Subject: Re: S. 16 Planning Application No. A/YL-KTN/1142 - Departmental Comments

A/YL-KTN/1142 Drainage Proposal R-to-C for 1-9-2025

Temporary Warehouse (Excluding Dangerous Goods Godown) with Ancillary Facilities and Associated Filling of Land for a Period of 3 years at Lot 1864 (Part) in D.D. 107 and Adjoining Government Land, Kam Tin, Yuen Long, New Territories

(Application No.:A/YL-KTN/1142)

Drainage Proposal - LAYOUT

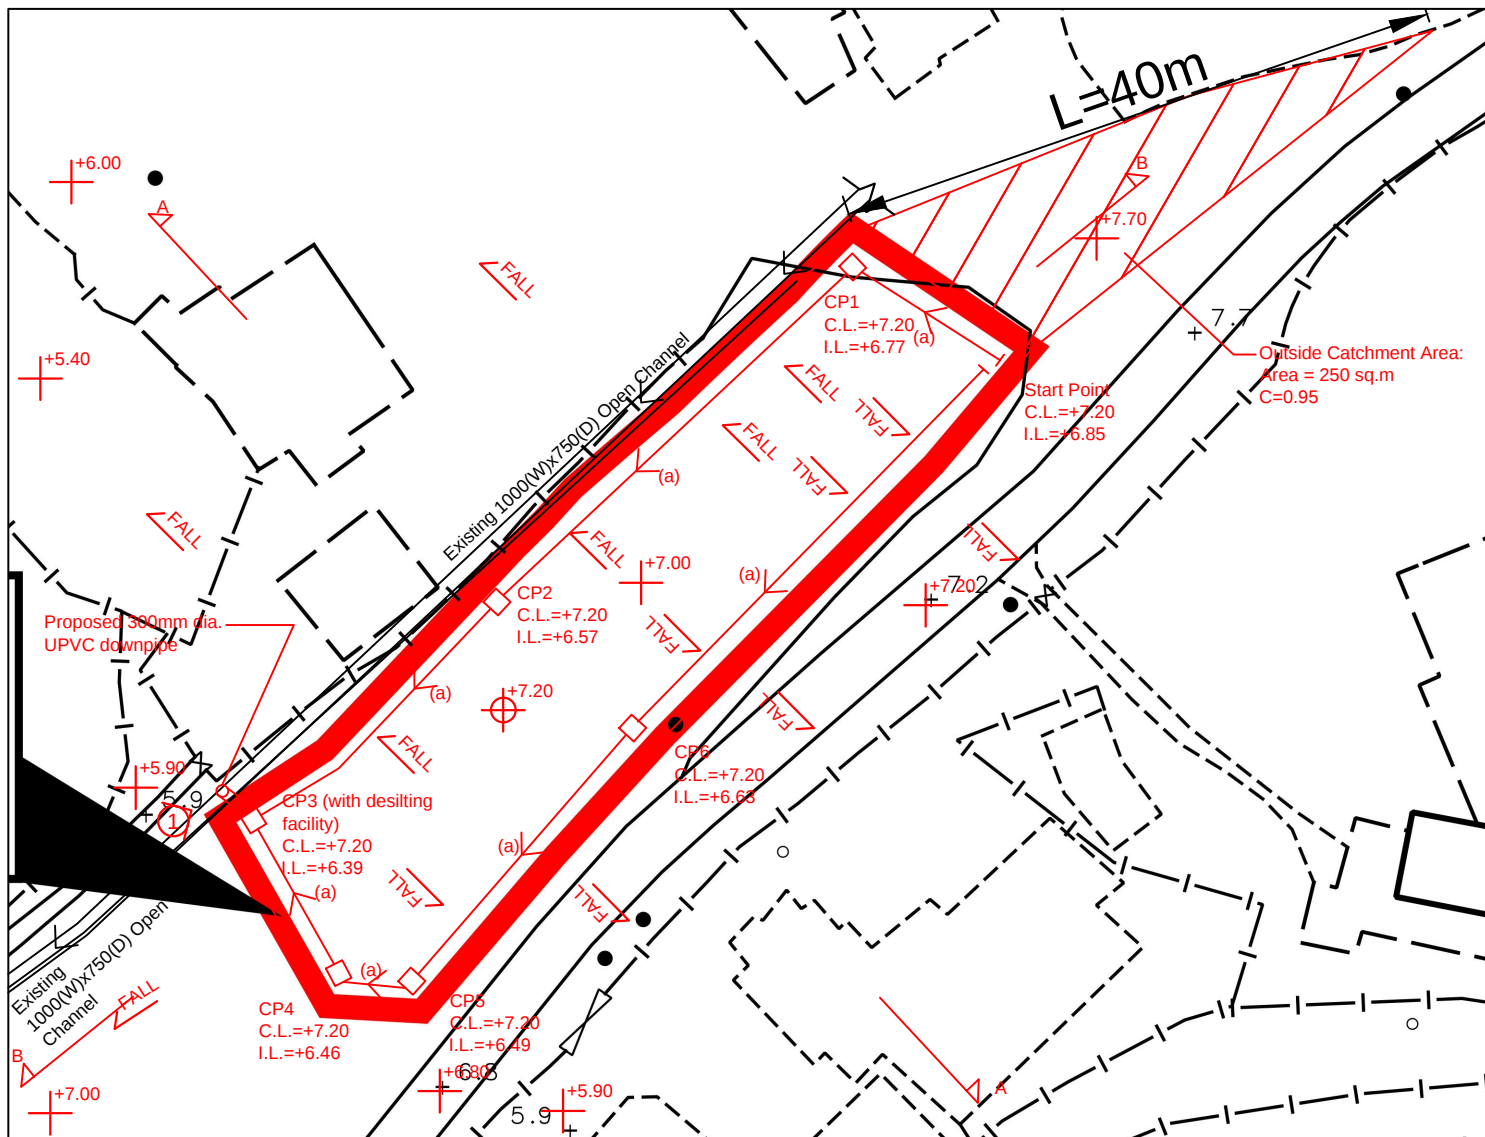
- (i) External catchment has been considered, the proposal is updated accordingly.
- (ii) The discrepancies of the levels has been revised.
- (iii) The proposed formation level shall be flushed with adjoining ground, no overland flow would be affected.

- (i) It is indicated.
- (ii) Peripheral channel has been provided.
- (iii) Hydraulic calculation of the proposed drainage facilities has been provided.
- (iv) More photos are attached for reference.
- (v) Hydraulic calculation of the existing drainage facilities to be discharged has been provided.
- (vi) It is demonstrated.
- (vii) Noted,
- (viii) Noted.

CATCHPIT WITH TRAP
(SHEET 1 OF 2)

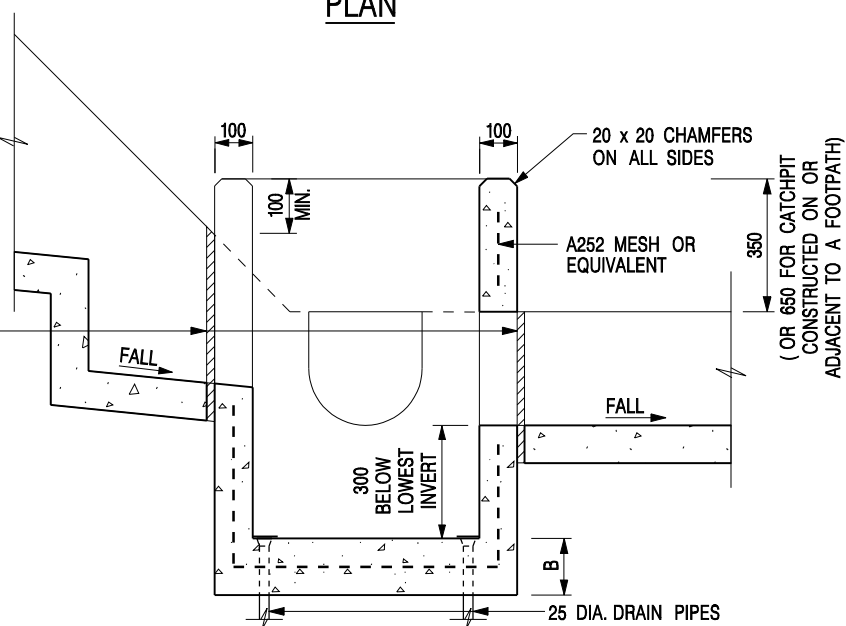
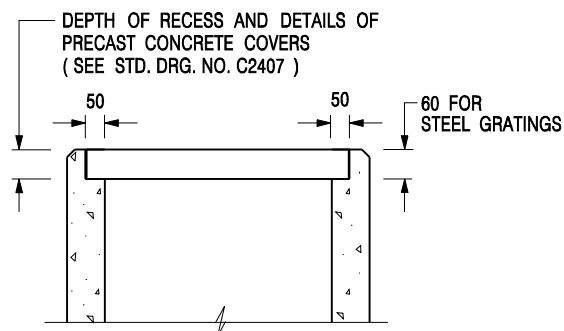
- (i) Updated C2406 is provided.
